Application: 2017/2550/L

Address: Leon Restaurant, Unit 2, The Brunswick Centre

On behalf of the Brunswick Centre Tenants and Residents' Association, I wish to object to the application by Leon Restaurants for retrospective Listed Building Consent for the installation (not simply replacement, as the application states) of plant at The Brunswick Centre.

DRG NO: Q16-147-M01 REV: B

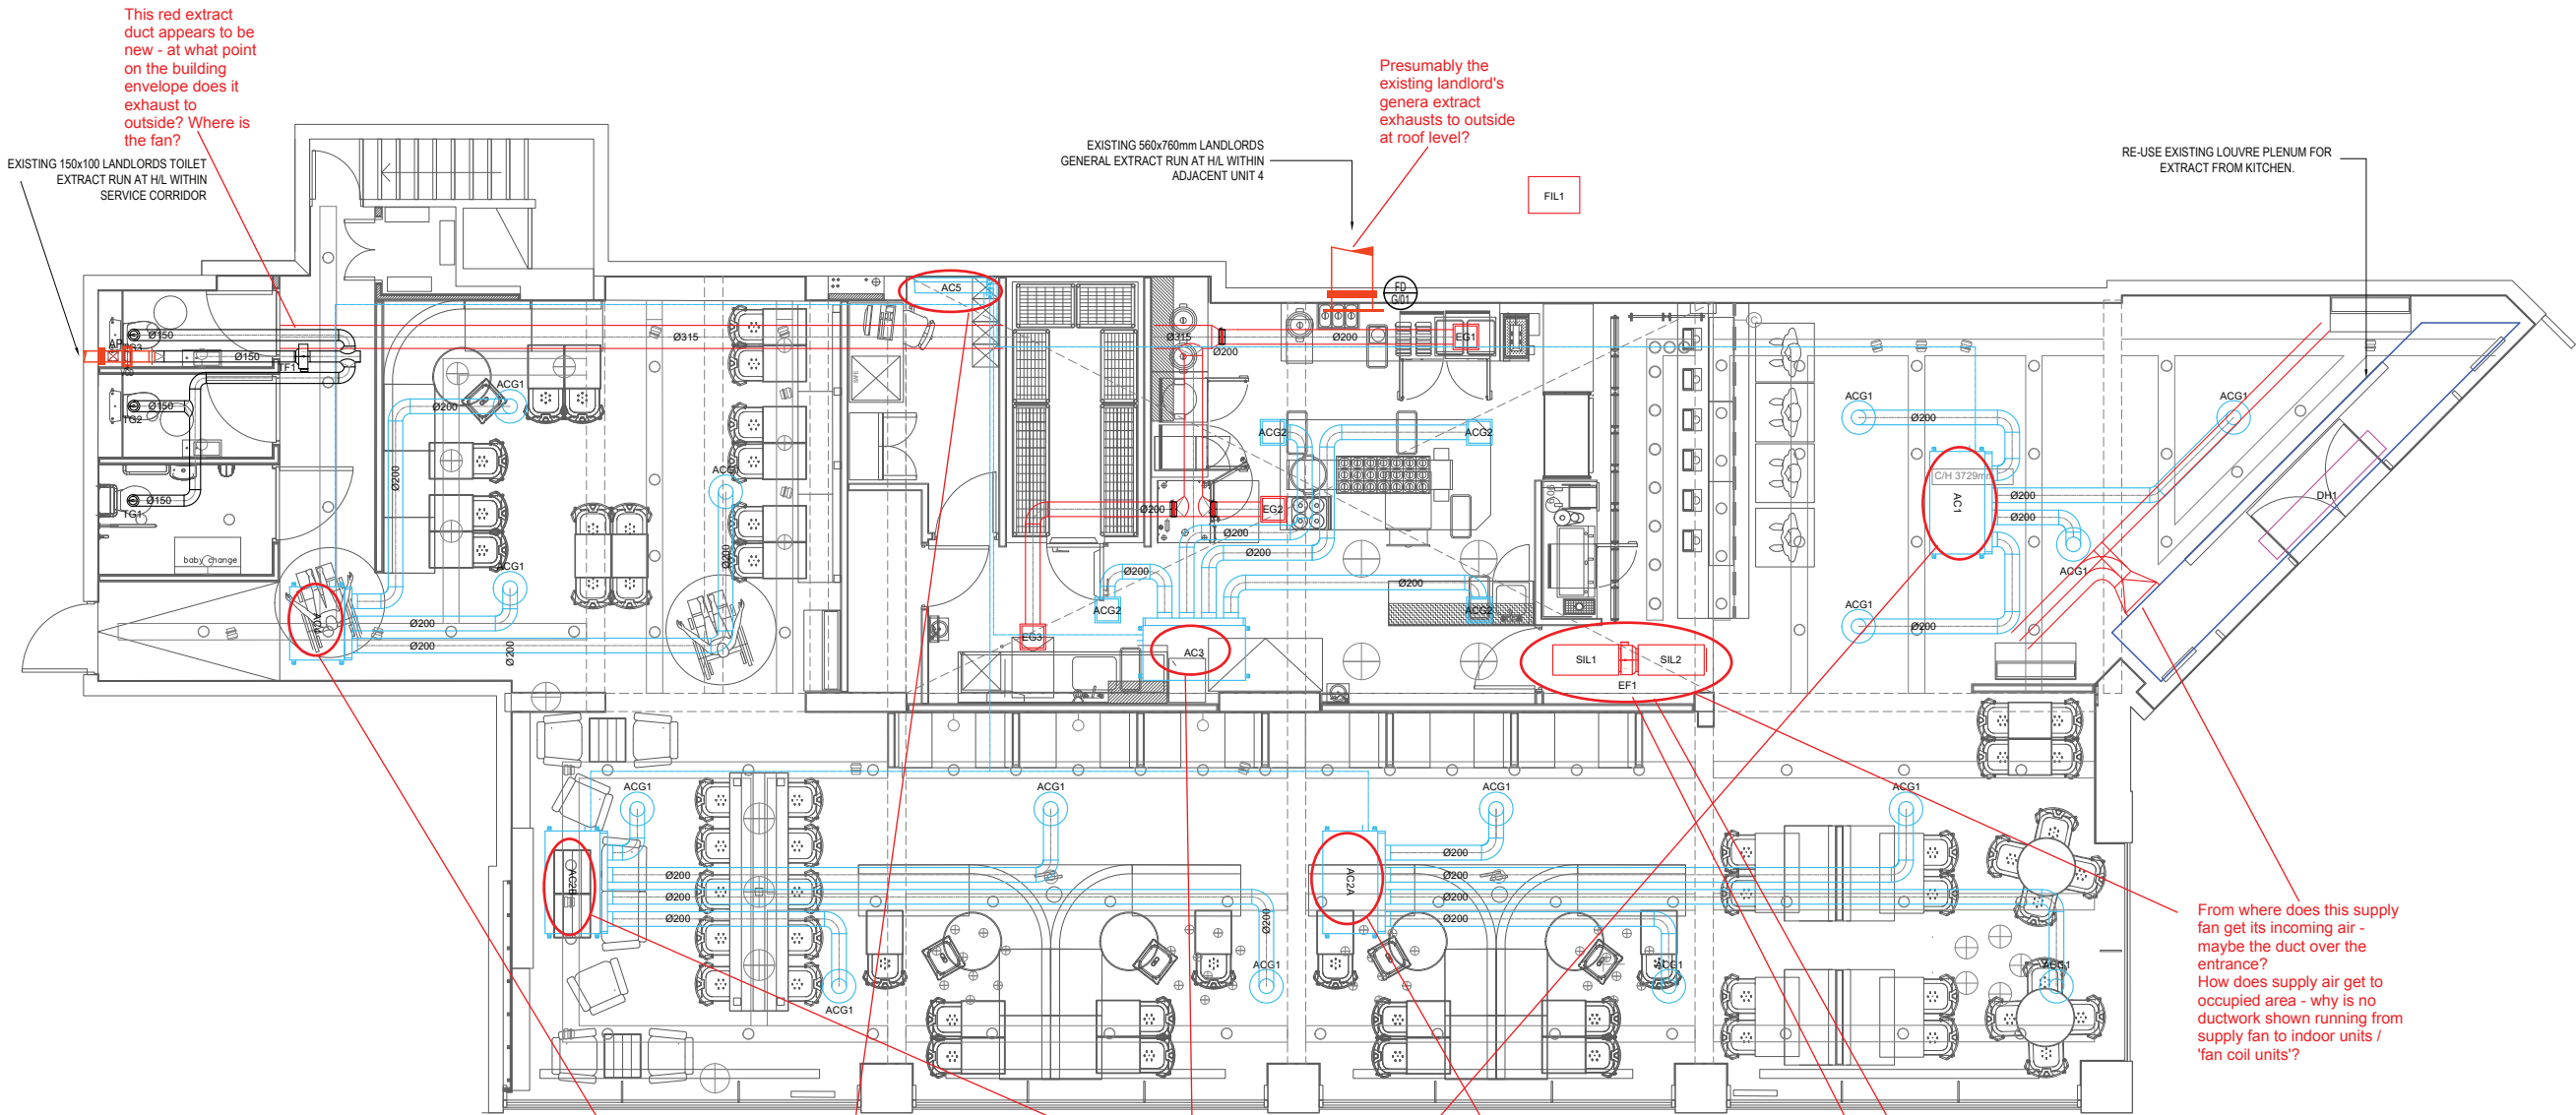
- b. Much of drawing Q16-147-M01 "Proposed HVAC layout [of the basement]" is blank, and does not show in any substantive sense what is proposed, including plant positions, duct routing, sound attenuation etc.. However, what is clear is that the drawing indicates that all of the plant to be installed in the basement is manufactured by Toshiba, whereas that shown in the plant technical details and the photographs is manufactured by Daikin. In addition, what is visible of the layout does not accord with the photographs provided.

- d. Drawing Q16-147-M01 "Proposed HVAC layout [at ground floor]" is inaccurate and incomplete. The marked up plan attached notes the points where the information provided is incomplete or is likely to mislead. In particular, the drawing gives no information on how air is supplied to the restaurant, and where the air extracted is discharged. Note also that this drawing again refers solely to Toshiba plant, when the applicant has provided information only on Daikin plant.
